UNITED STATES PATENT AND TRADEMARK OFFICE

10/518,785

Fritz Gyger

Office Action Summary	Application No. 10/518,785	Applicant(s) GYGER, FRITZ
	Examiner JESSICA L. MYERS	Art Unit 3746

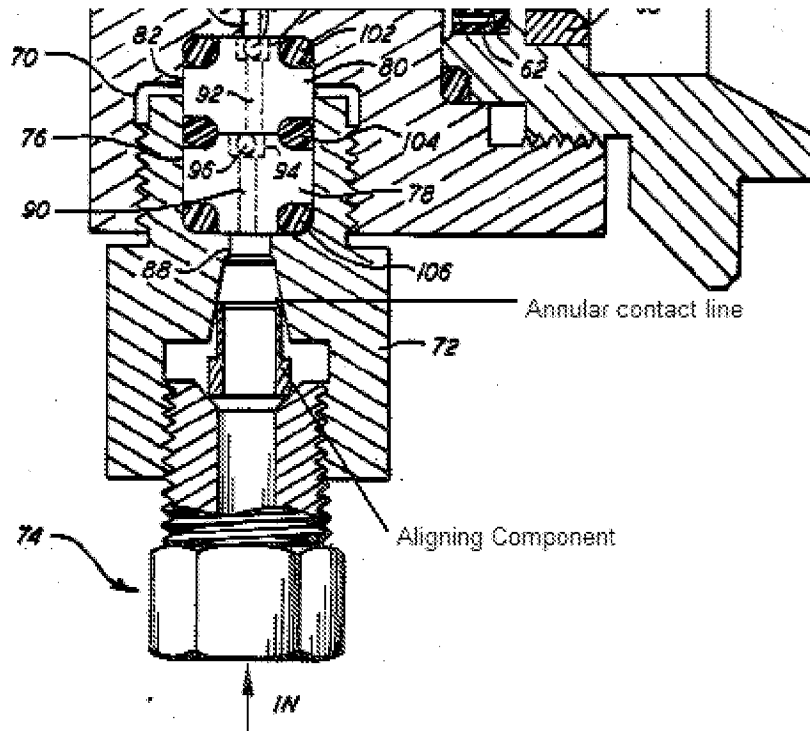
Leka et al. teach a pump for delivering precisely determined, small liquid flows under high pressure (pump assembly shown in figure 1, and check valve bores shown in figure 3), the pump comprising:

at least one pump device including a displacement chamber (piston cylinder (86)), at least one working medium access bore formed in the displacement chamber and a piston (piston end (30)) that is movable in the displacement chamber;

a detachable connecting assembly positioned at the working medium access bore (including check valve fitting (72) and conventional end connection (74)), the connecting assembly including at least one pair of sealing surfaces (there is an aligning

component located between the fitting (72) and the connection (74) that has a sealing surface as indicated in the figure below), the first sealing surface being dome-shaped and convex (the aligning component is convex and annular in shape) and the second sealing surface being concave and conical and non-complementary to the first sealing surface (the outlet passage in the fitting (72) is conical in shape), the first and second sealing surfaces contacting each other along at least one annular contact line without forming a contact along an entire area of either one of the sealing surfaces (the aligning component and the fitting (72) contact each other along an annular line), and the sealing surfaces having respective central openings defining a channel connected to the working medium access bore (each connecting component has a bore through its center, to allow liquid to flow into the pump).
